Special Council Meeting

**DA RESUBMISSION
POST JDAP DEFERRAL**

**50-52 MELVILLE PDE
SOUTH PERTH
4th MAY 2018**

RE: POST JDAP DEFERRAL RESUBMISSION
PROPOSED 36 STOREY MIXED-USE DEVELOPMENT
LOT 29 (#50-52) MELVILLE PARADE, SOUTH PERTH

4.2 SETBACK - PLAN COMPARISON

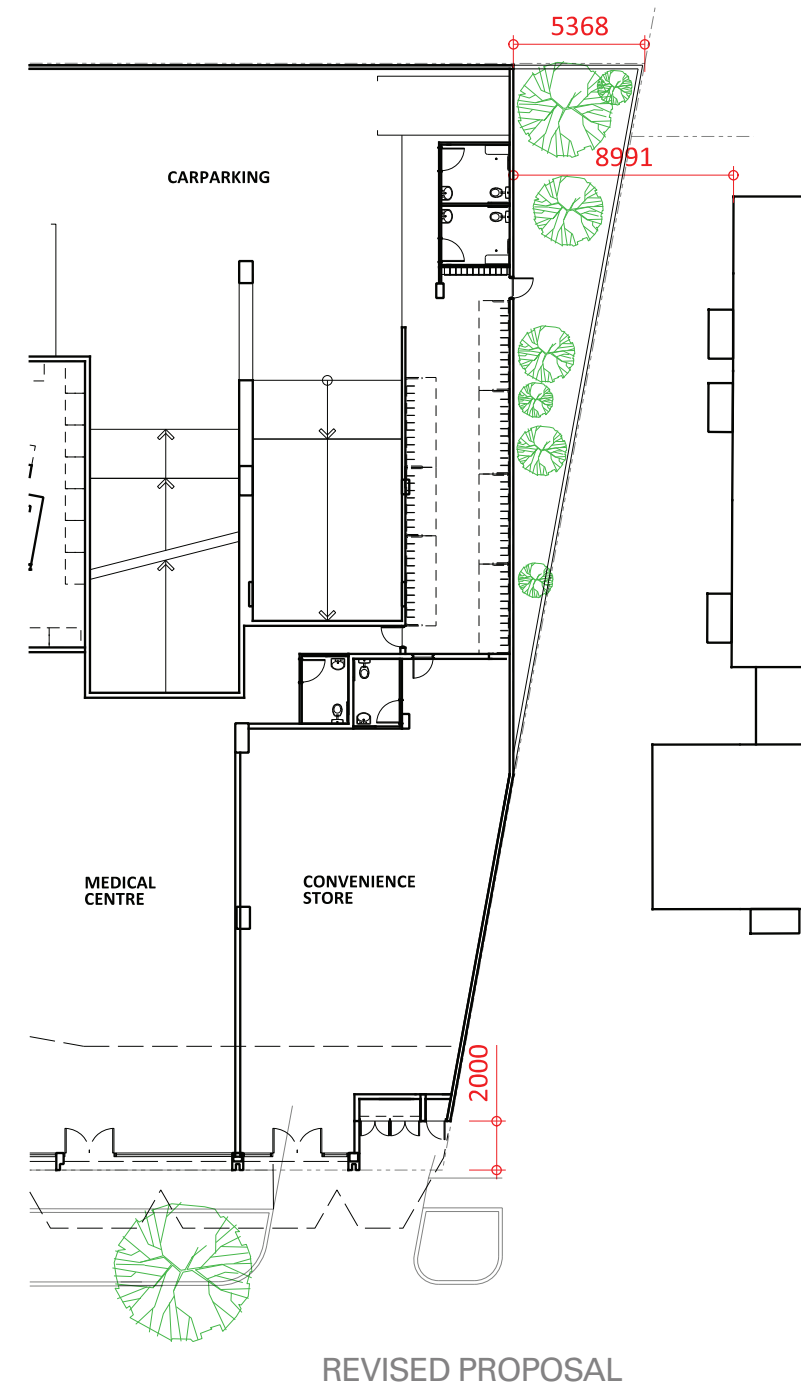
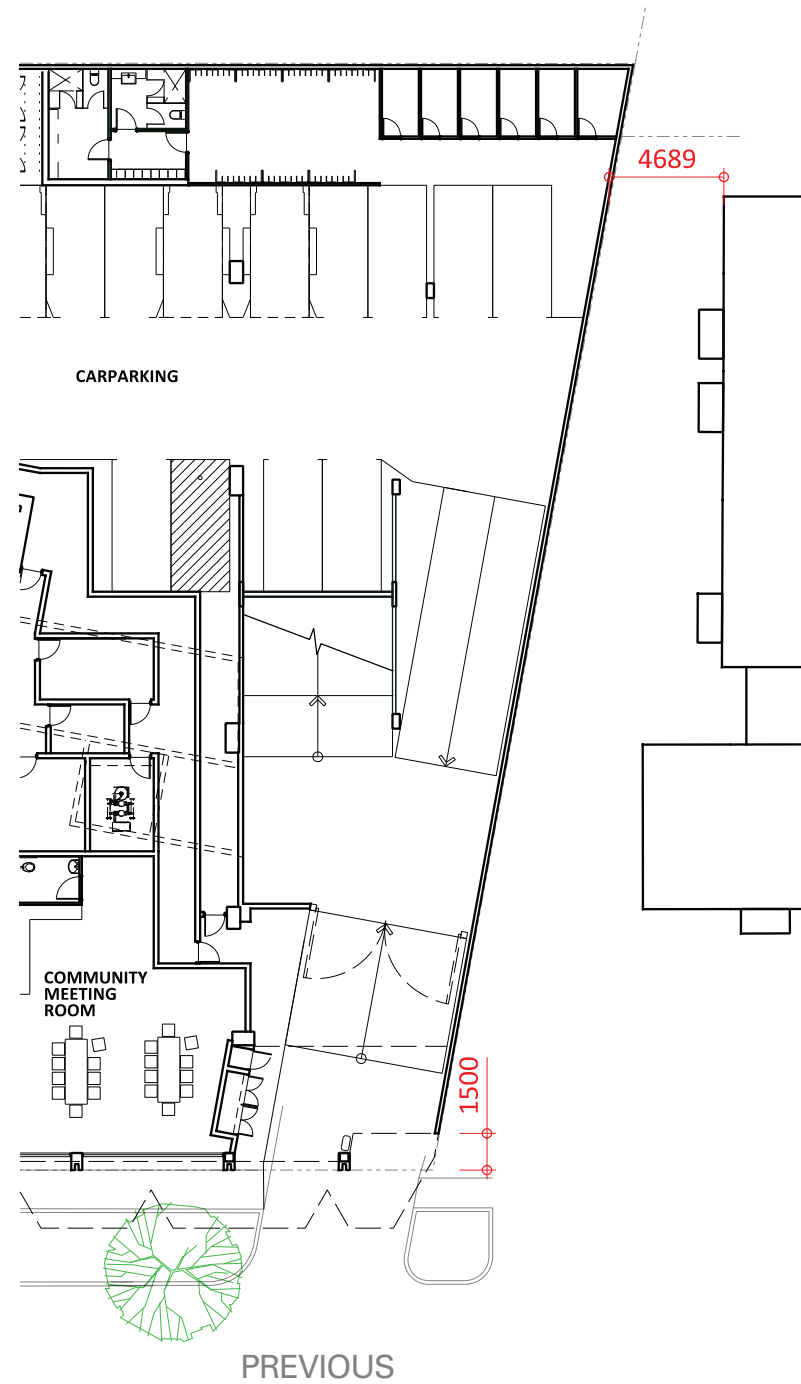
The lower podium has been setback at the northeastern corner to create a consistent 9m setback area, parallel to 3 Bownman Street.

The southeastern corner has also been setback to further improve sightlines.

4.3 SETBACK - PLAN COMPARISON

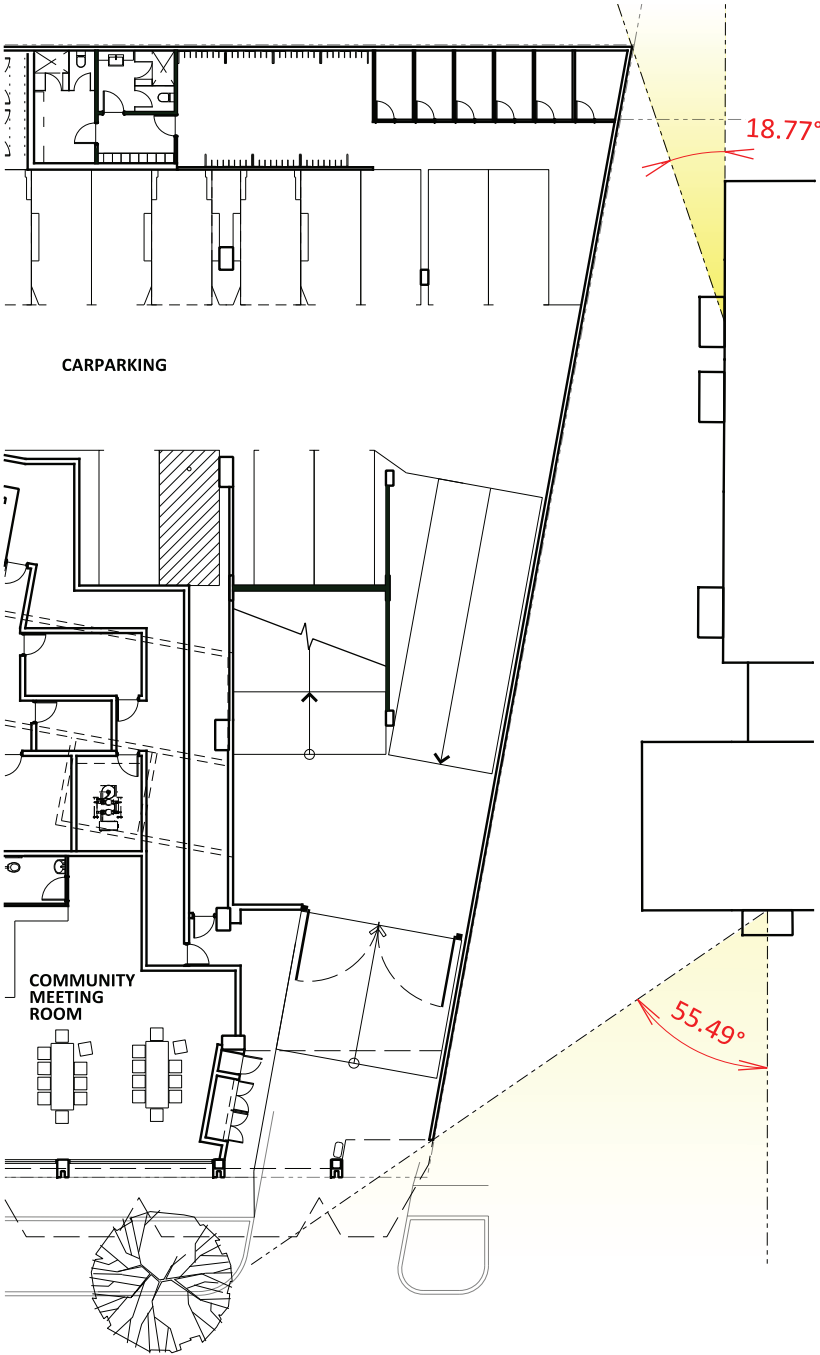
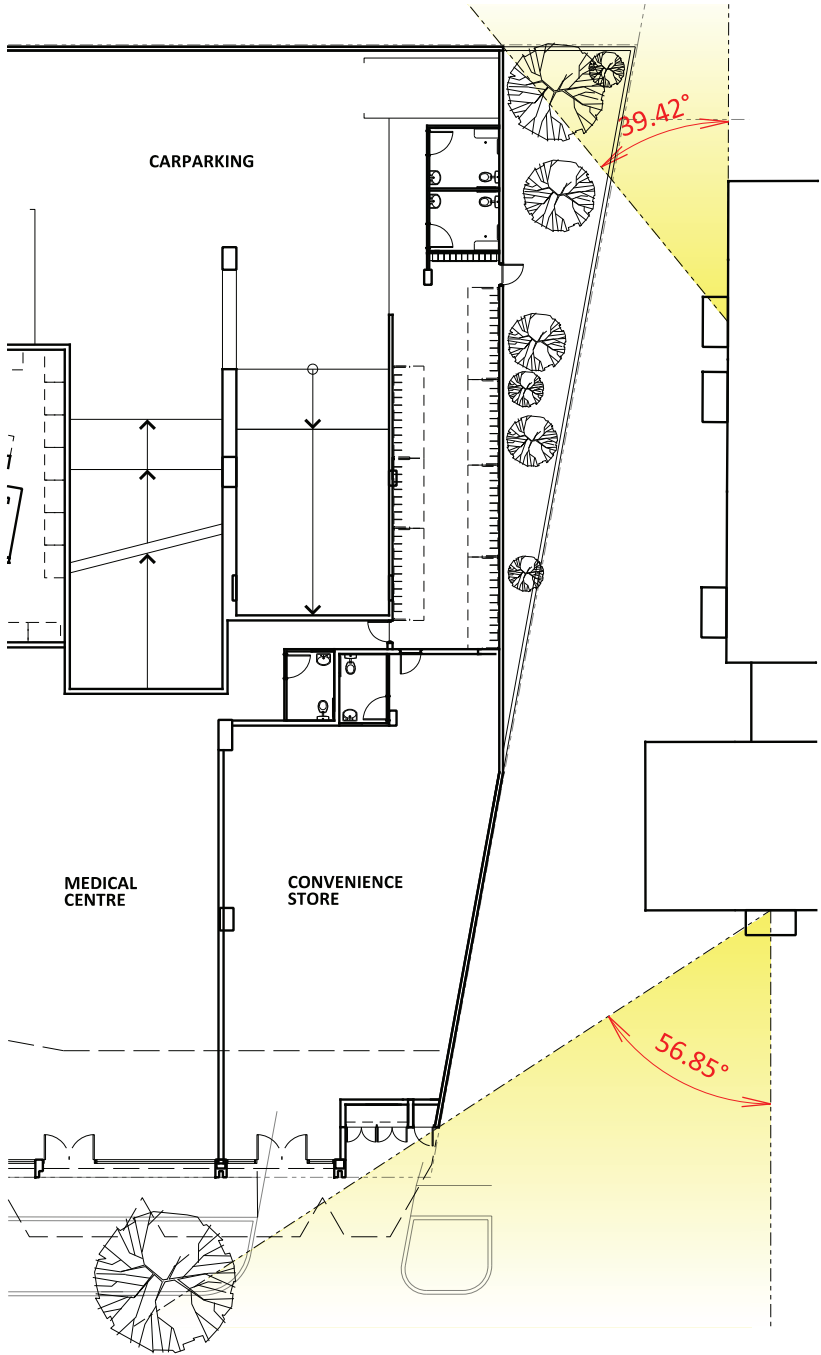
The additional podium setback improves sightline vision from 3 Bownman Street.

5.5 SHADOWS ON 21ST MARCH / 23RD SEPTEMBER - REVISED SCHEME

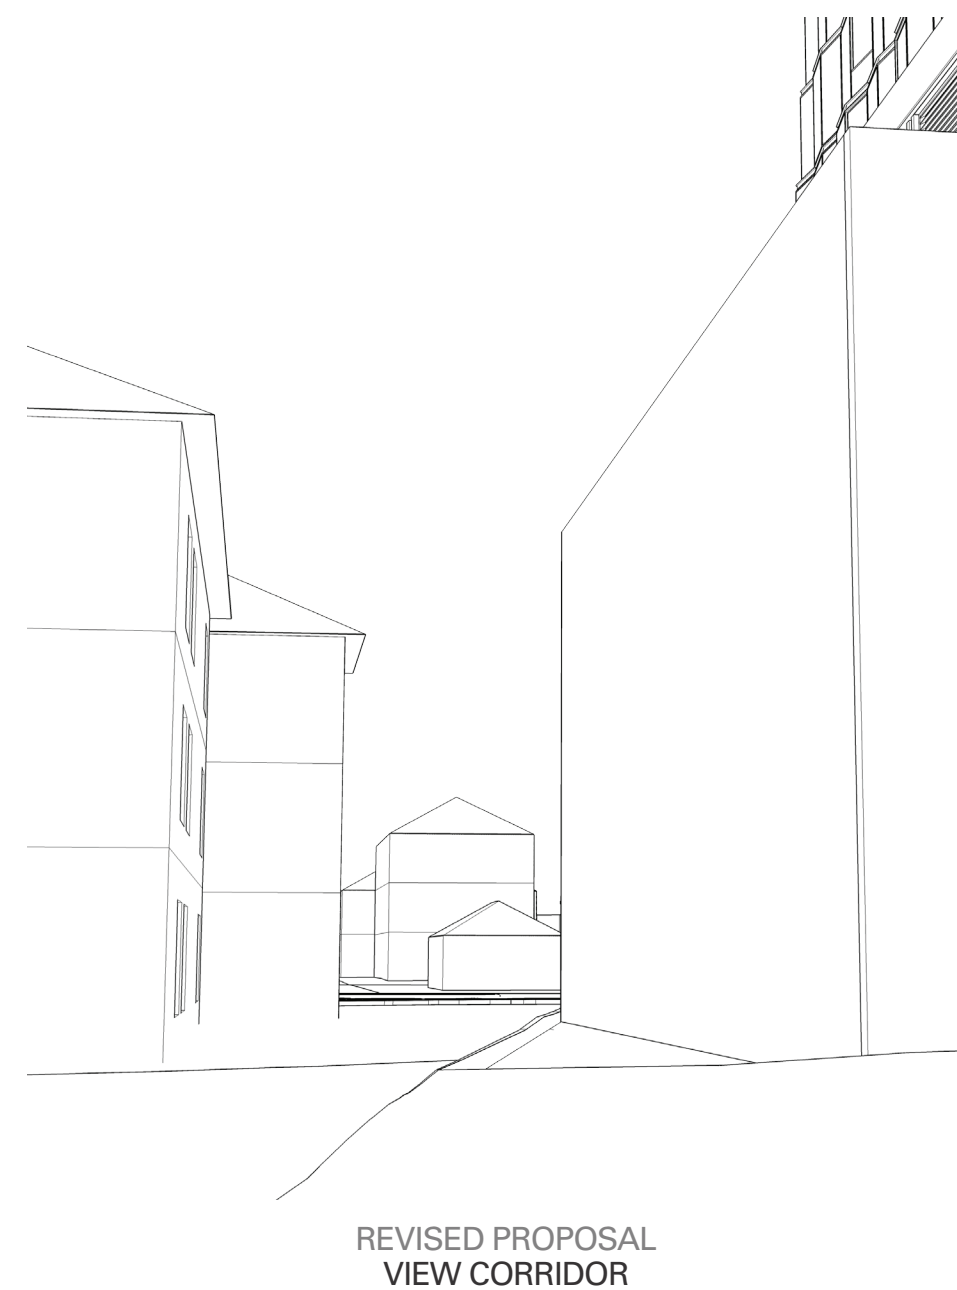
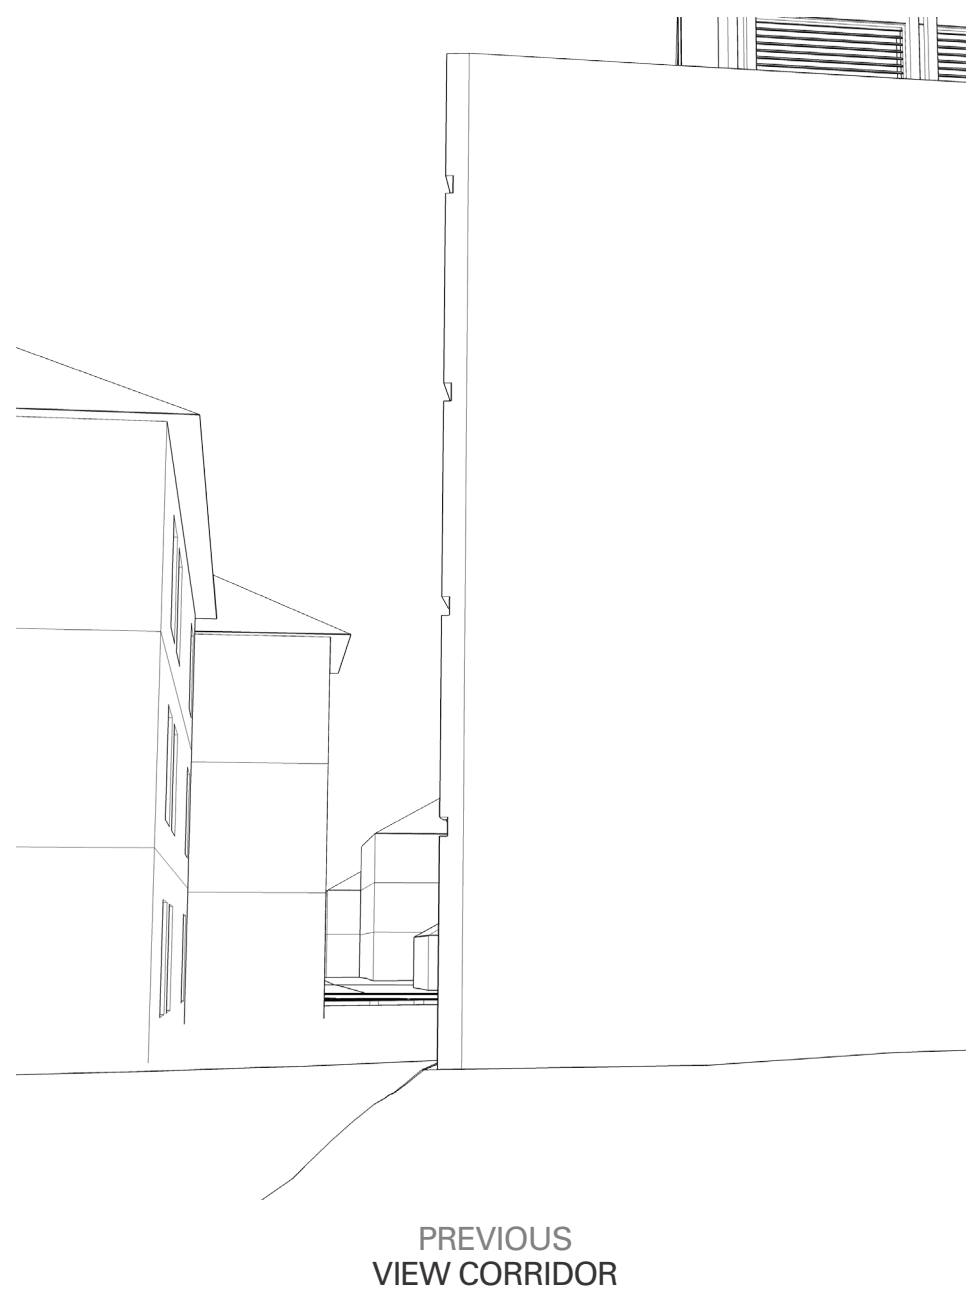
The revised design significantly improve the overshadowing impact to the adjoining neighbour. We have conducted several overshadowing studies at various time of the year. All the studies demonstrate that the new design provides addition of 1.5 to 2 hours sun access to 3 Bowman. Please refer to the attached overshadowing diagrams for detail.
